TO: Mayor Robert Price, City of Locust Grove
ATTN TO: Anna Williams, Planner II, City of Locust Grove
FROM: Mike Alexander, Director, ARC Center for Livable Communities
RE: Development of Regional Impact (DRI) Review

Name of Proposal: Locust Grove Phase III DRI 3805

Description: A DRI review of a proposal to construct two industrial warehouses totaling 962,220 SF on a 101-acre wooded site with streams and wetlands off of Price Road and Bethlehem Road in the City of Locust Grove in Henry County.

Drawing Title
**DRI #3805 PLAN
EXHIBIT**

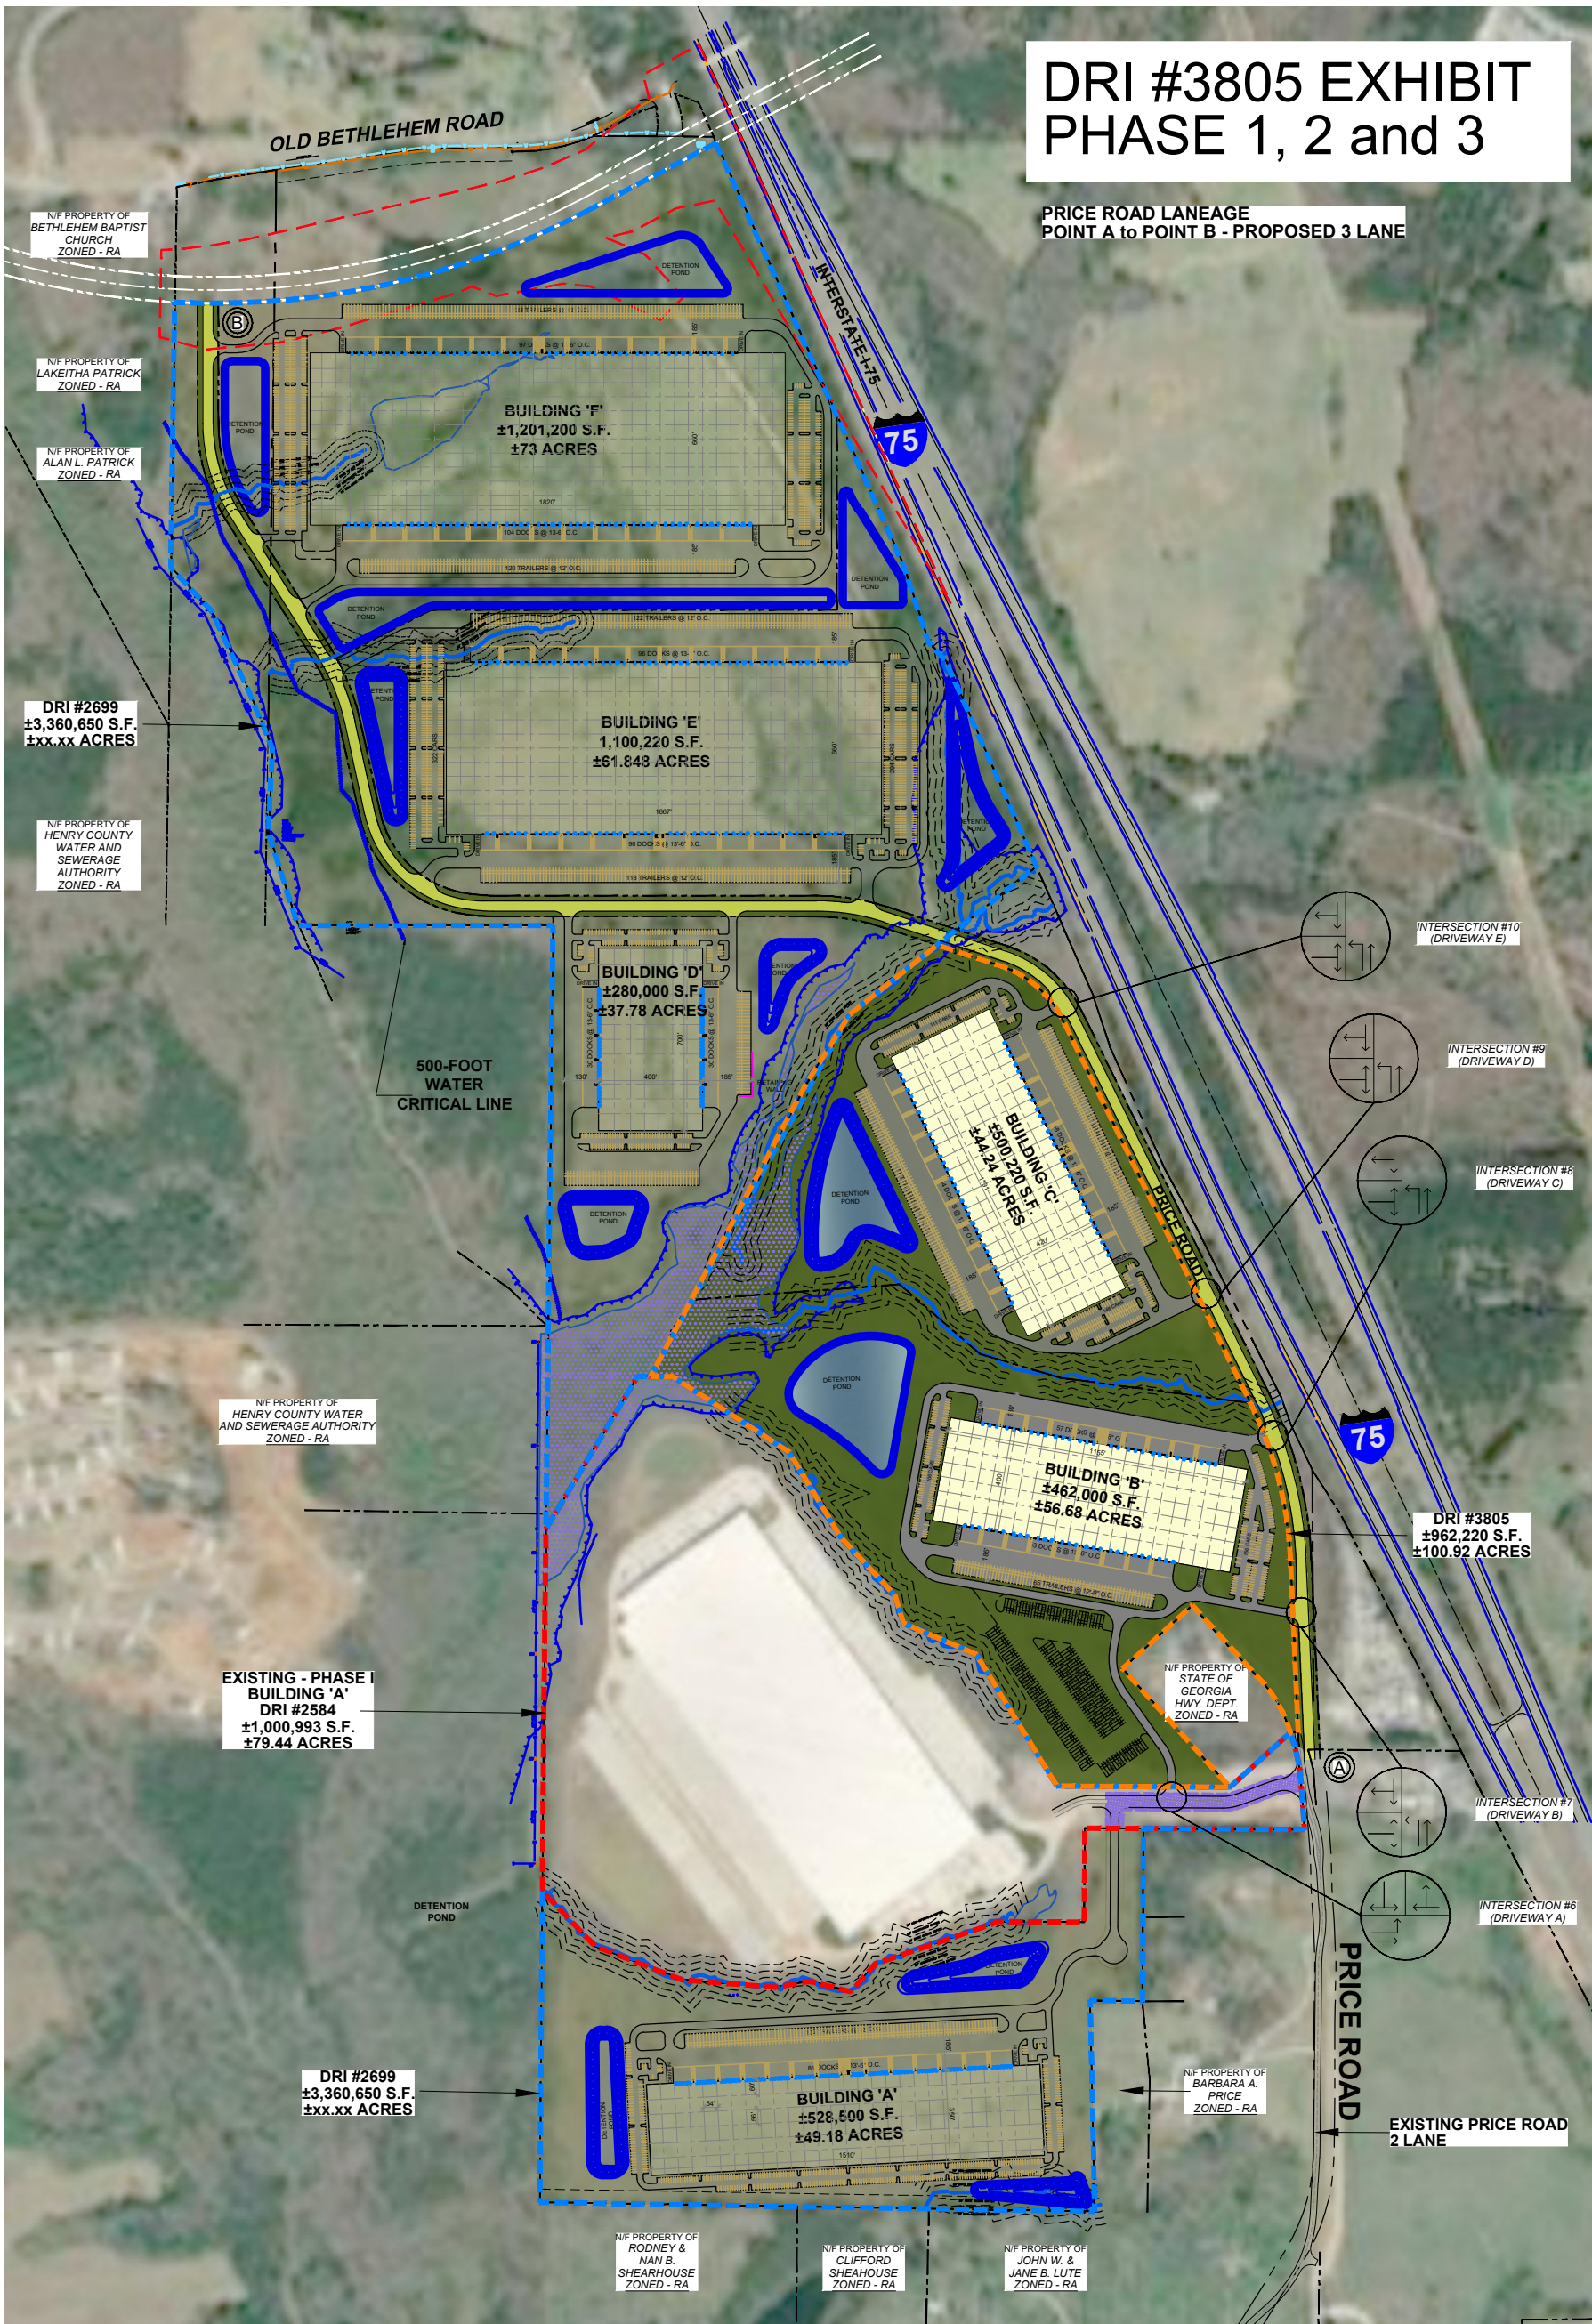
A total of 521 car parking spaces and are proposed which is substantially more than the minimum 200 required. A total of 388 truck trailer spaces and 232 truck docks are provided. No EV charging spaces appear to be identified; provision of adequate EV charging spaces would be supportive of regional EV infrastructure policies.

The plans also show Buildings E and F and their associated parking lots, loading areas and detention ponds being sited directly over the two northernmost streams or their buffers. The proposed site plan also shows a parking/loading area intrusion into the 75-foot buffer of a branch of the central stream at the eastern end of Building E. The only other intrusion into the buffers shown is an internal road crossing the central stream just south of Building E, which is generally exempt under the Locust Grove ordinance. However, the site plan shows other areas of proposed development that are close to the mapped stream buffers. All intrusions other than the road crossing may require variances under the Locust Grove Stream Buffer Ordinance and the State Erosion and Sedimentation Act buffer.

Both the USGS coverage for the project area and the project site plan show two intermittent blue line streams crossing the property and flowing into an unnamed perennial tributary of Indian Creek to the west of the project site as well as a third intermittent stream ending in wetlands before it reaches the perennial stream. One stream starts from an onsite pond at the northern end of the property. The second is in the middle of the property with branches off of it as shown on the USGS coverage and the site plan. The third stream shown ending in wetlands is at the southern end of the project property. The submitted site plan also shows a short stream just south of the northernmost mapped stream that is not shown on the USGS coverage. Although not labelled, the site plan shows the 50-foot buffer and 75-foot impervious setback required by the Locust Grove Stream Buffer Ordinance and the 25-foot State Erosion and Sedimentation Act buffer on all streams shown on the site plan. However, the plans also show Buildings E and F and their associated parking lots, loading areas and detention ponds being sited directly over the two northernmost streams or their buffers. The proposed site plan also shows a parking/loading area intrusion into the 75-foot buffer of a branch of the central stream at the eastern end of Building E. The only other intrusion into the buffers shown is an internal road crossing the central stream just south of Building E, which is generally exempt under the Locust Grove ordinance. However, the site plan shows other areas of proposed development that are close to the mapped stream buffers. All are intrusions other than the road crossing may require variances under the Locust Grove Stream Buffer Ordinance and the State Erosion and Sedimentation Act buffer.
